De/From: Nuria ENCINAS
Safety Department

Date: Geneva, 26 May 2016

Underwear overlap, Update of Art.2 "Flame resistant clothing" of APPENDIX L CHAPTER III "Drivers' Equipment"

Figure 1 – minimum overlapping at the neck area

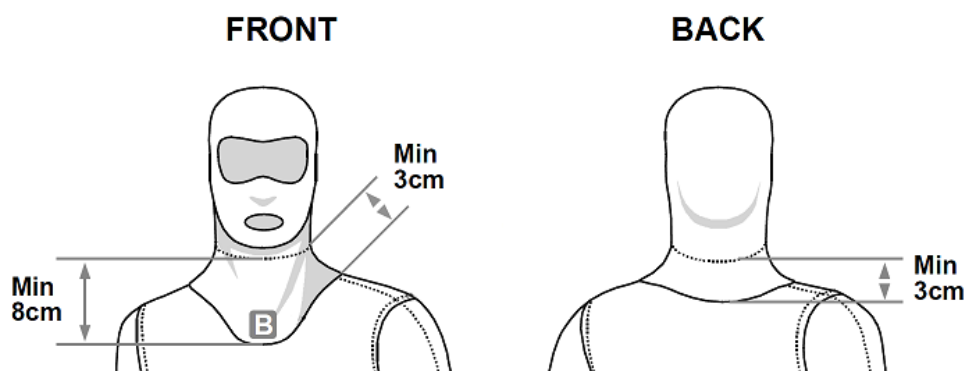
For this reason, the FIA has decided to define a minimum overlap required in the neck area (between the balaclava and the top underwear) of 3cm, except on the front central line where the overlap shall be at least of 8cm as shown in Figure 1.

This requirement will be applicable from 01.01.2017 in circuit competitions, hill-climbs, special stages of rallies and selective sections of cross-country competitions entered on the International Sporting Calendar and any other regulation following Appendix L of the International Sporting Code. The updated regulation can be found in the last section "Modifications for 2017" of Appendix L to the International Sporting Code.
